Pacific Grove Unified School District
435 Hillcrest Avenue, Pacific Grove, CA 93950
Robert Down Elementary School Site Improvements
Notice to Bidders - Addendum 03

Addendum Date: 3/23/2026

AD03-01: Revisions to Project Manual

AD03-02: Pre-Bid Questions and Answers

20 ENLARGED PLAYGROUND PLAN - EAST
SCALE: 1/16" = 1'-0"

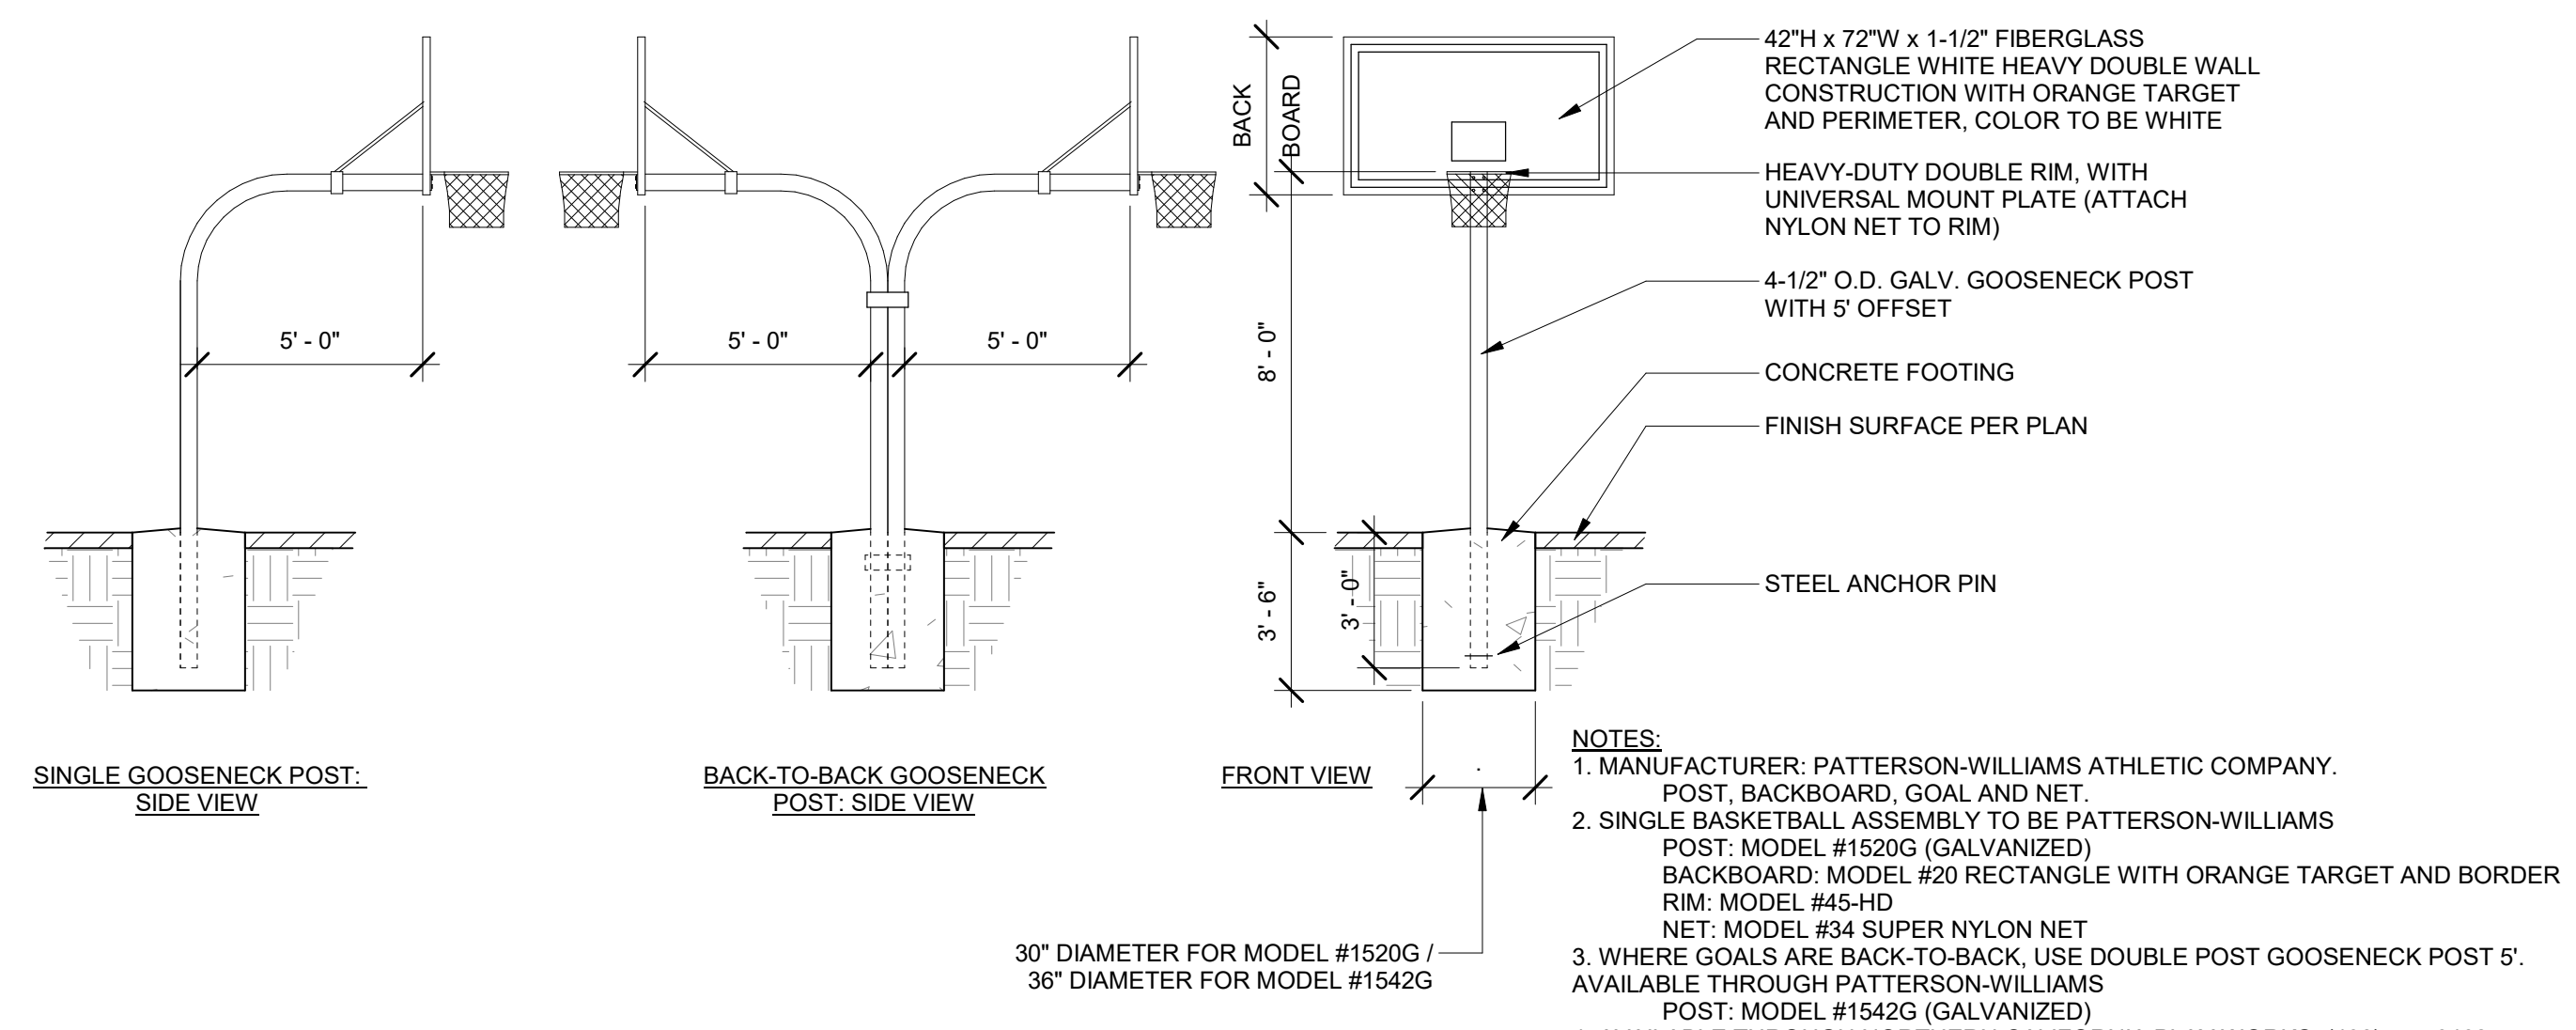
1. Is the concrete walkway, landscape and asphalt ramp next to the East Playground part of the base bid or additive work?
Only asphalt paving shown within the boundary indicated on Addendum 3 revised sheet A1.11 is part of Alternate 1. All other scope is part of the base bid.

- ITEM 3D.010** **Sheet A1.22 SITE DETAILS** – Clarify dimensions of world map striping per 18/A1.22 ENLARGED PLAYGROUND PLAN - WEST.
- ITEM 3D.011** **Sheet A1.22 SITE DETAILS** – Clarify add alternate limit of work area per 20/A1.22 ENLARGED PLAYGROUND PLAN - EAST.

SHEET #
AD3-C1.1

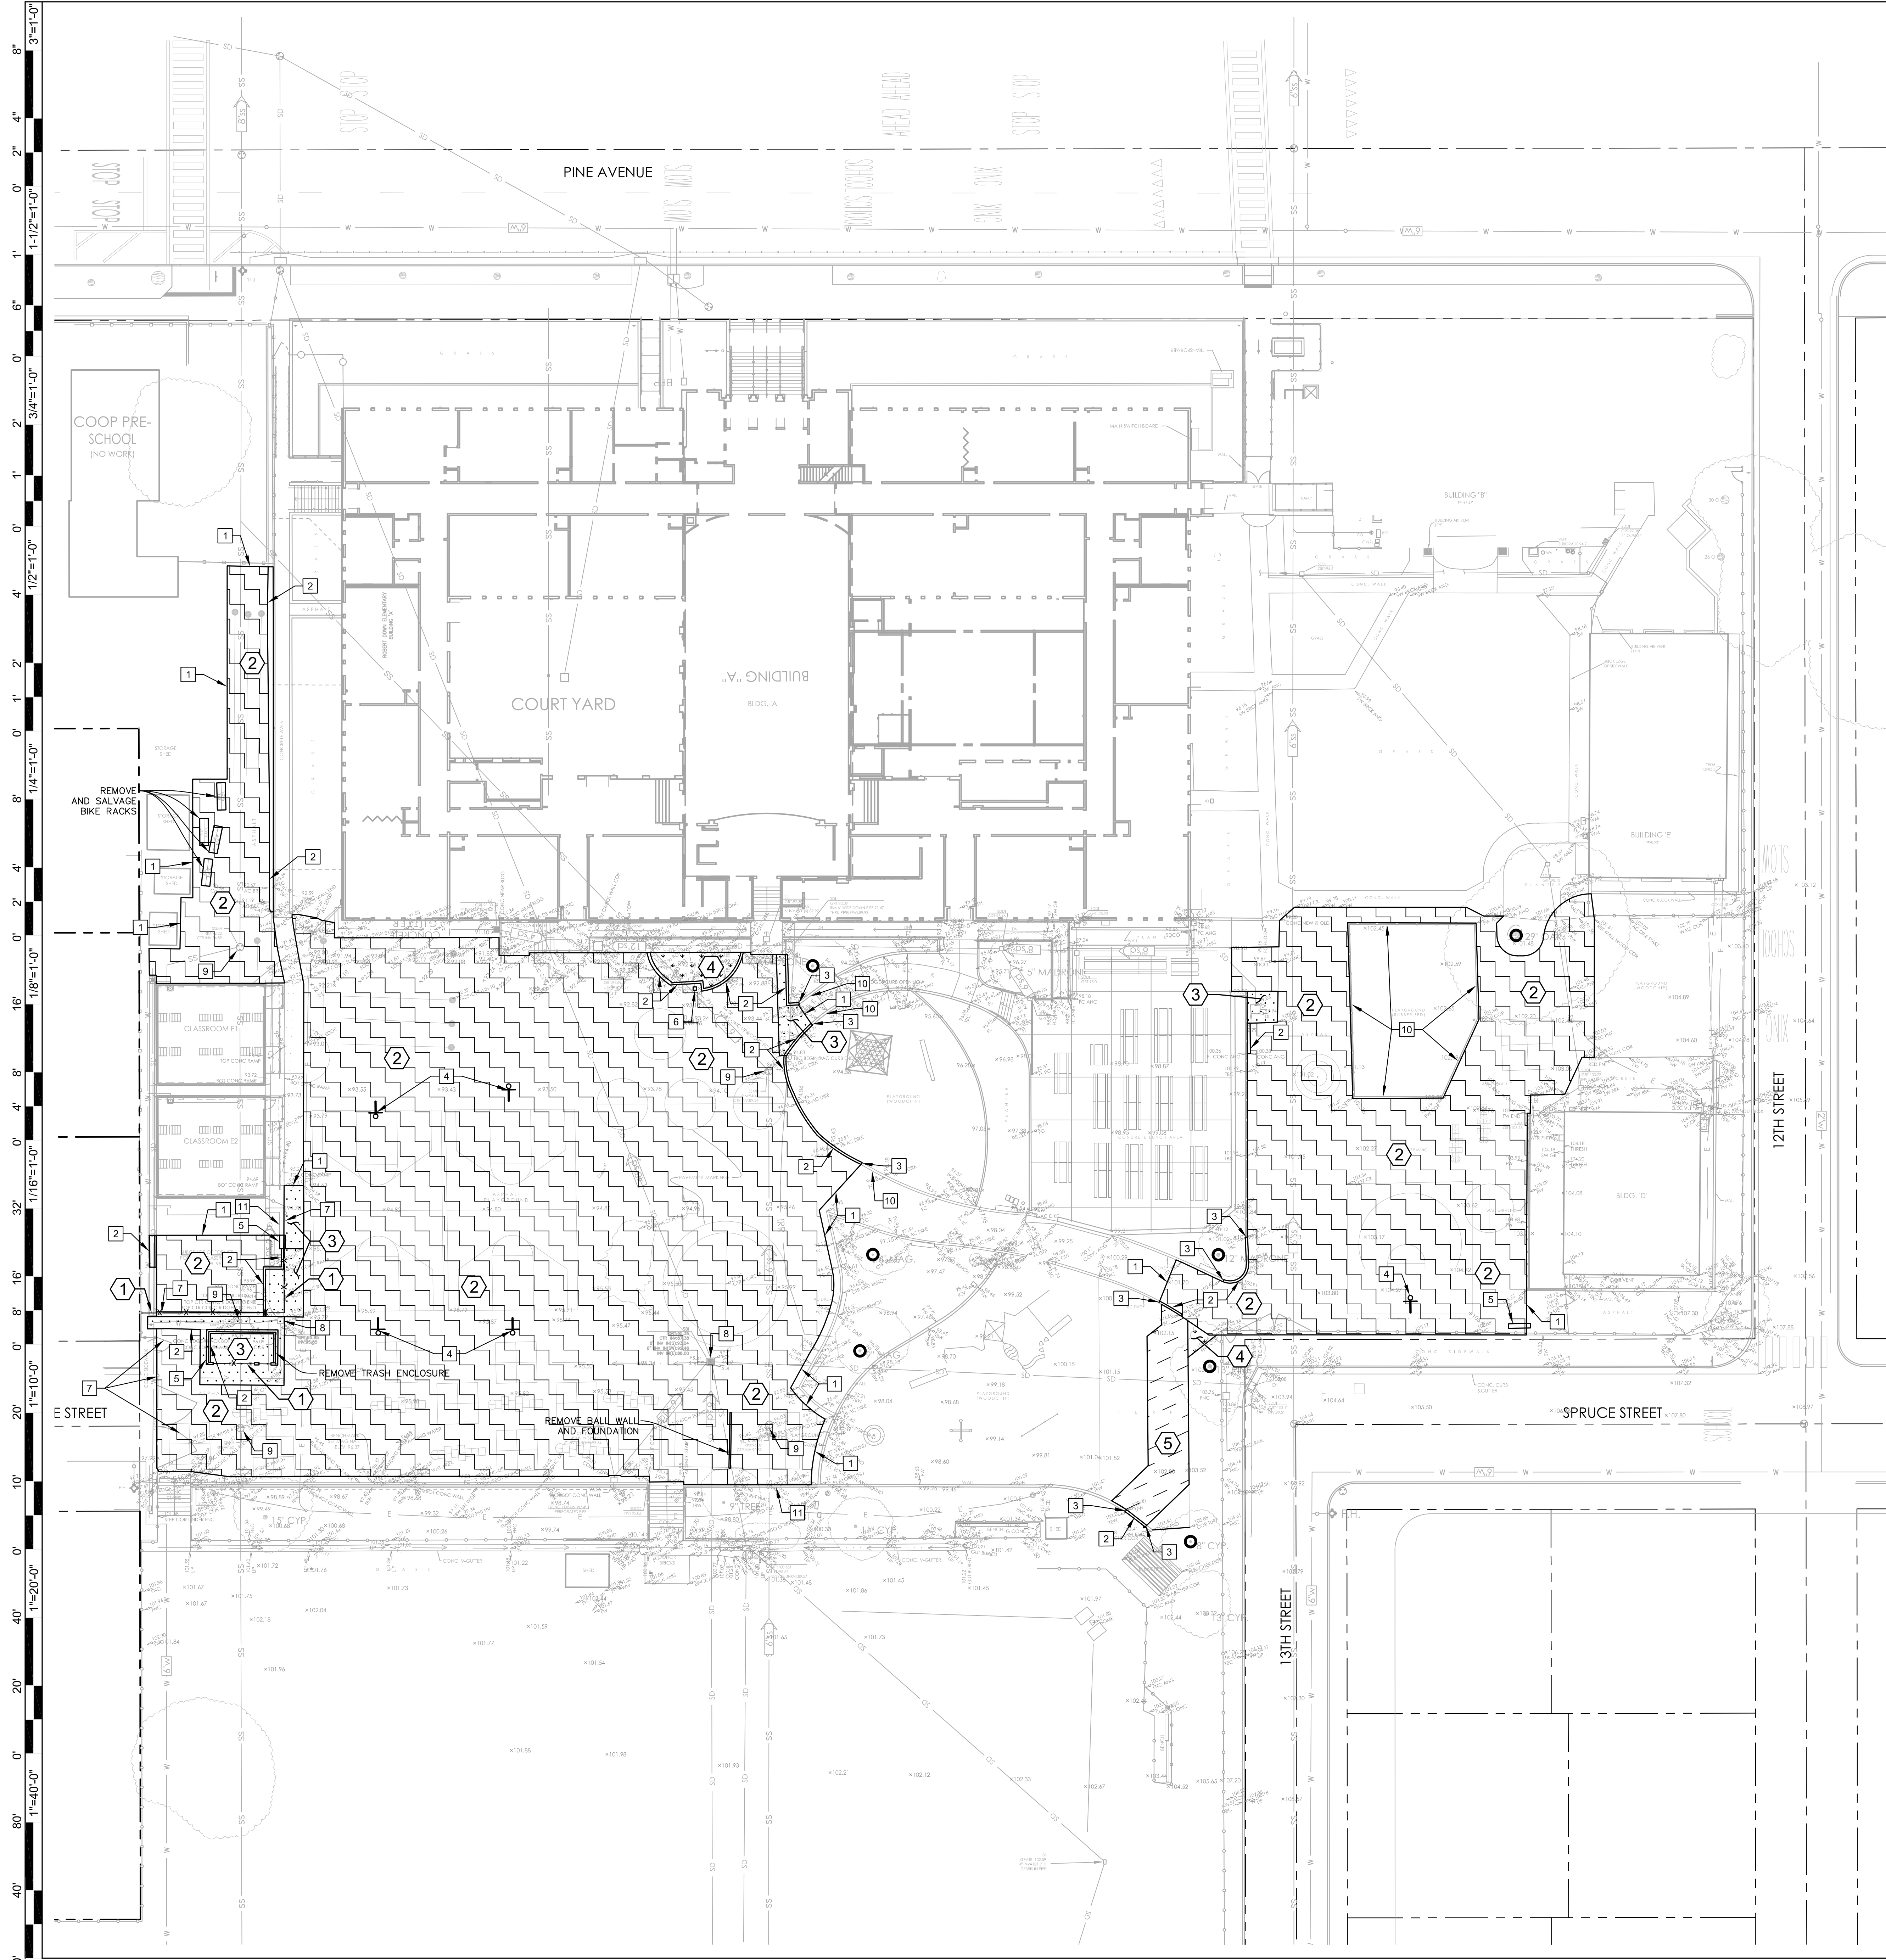
2. Note that project address is shown as 615 Sunset Drive - Sheets C1.1, C6.1, C7.1 & C7.2.
This is a typographical error that is corrected on revised sheets issued as part of Addendum 3.

- ITEM 3D.012** **C0.1 – NOTES, LEGEND & INDEX** –
Add: Geotechnical Report information added.
Add: Underground notes 8 for Storm Drain Cleaning added.
- ITEM 3D.013** **C1.1 – DEMOLITION PLAN**
Revise: Demolition Keynote 5 revised.
- ITEM 3D.014** **C2.2 – GRADING & DRAINAGE PLAN**
Revise: Grades and Slopes revised at revised Concrete paving sidewalk, Synthetic turf and Curbs west of Spruce Street added.
Revise: Grades and Slopes revised at revised Concrete paving sidewalk, Synthetic turf and Curbs nearby existing Play Structure.
Revise: Existing Drain Inlet Rim elevation revised nearby existing Play Structure.

PROJECT #
 DCA 25.054
 CEI 3263
 SHEET #
AD3-C3.1
 ISSUE DATE:
 12/22/2026

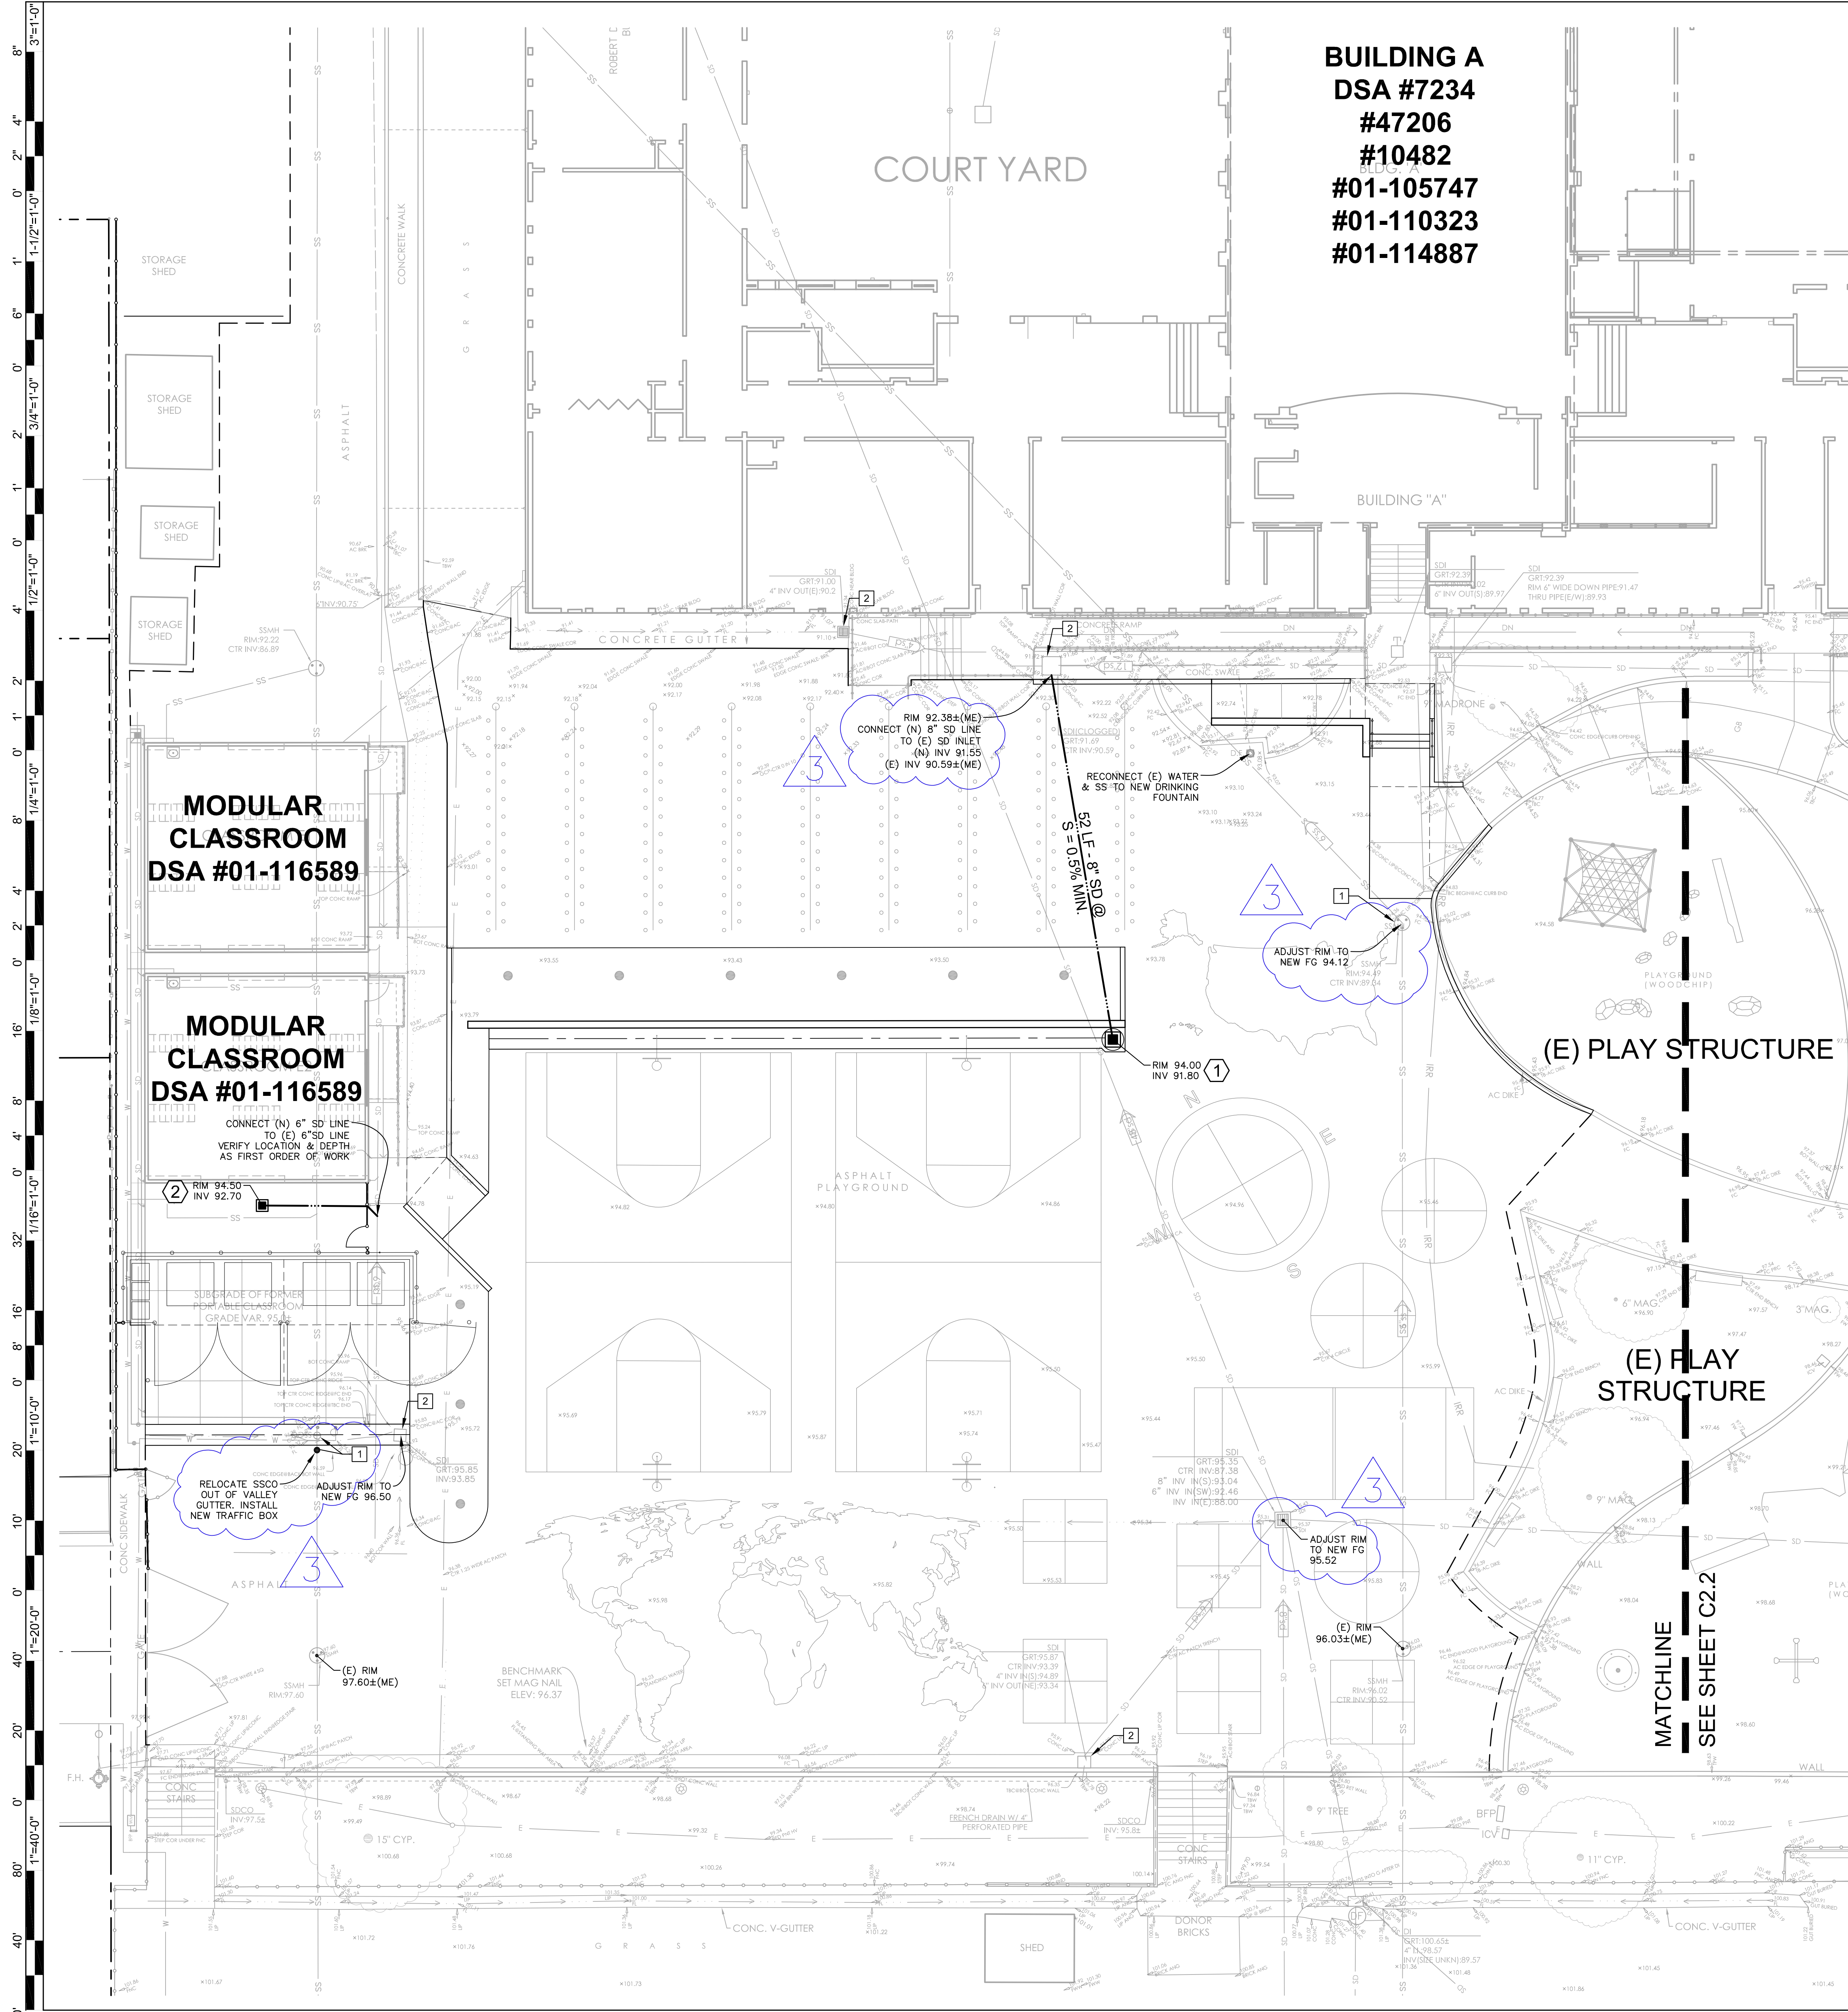
ITEM 3D.015 C3.1 & C3.2 – UNDERGROUND UTILITIES PLAN
Revise: Existing Drain Inlet Rim elevation revised nearby existing Play Structure.
Revise: Existing Drain Inlet invert grade revised.
Revise: Existing SSCO relocated out of Valley Gutter.
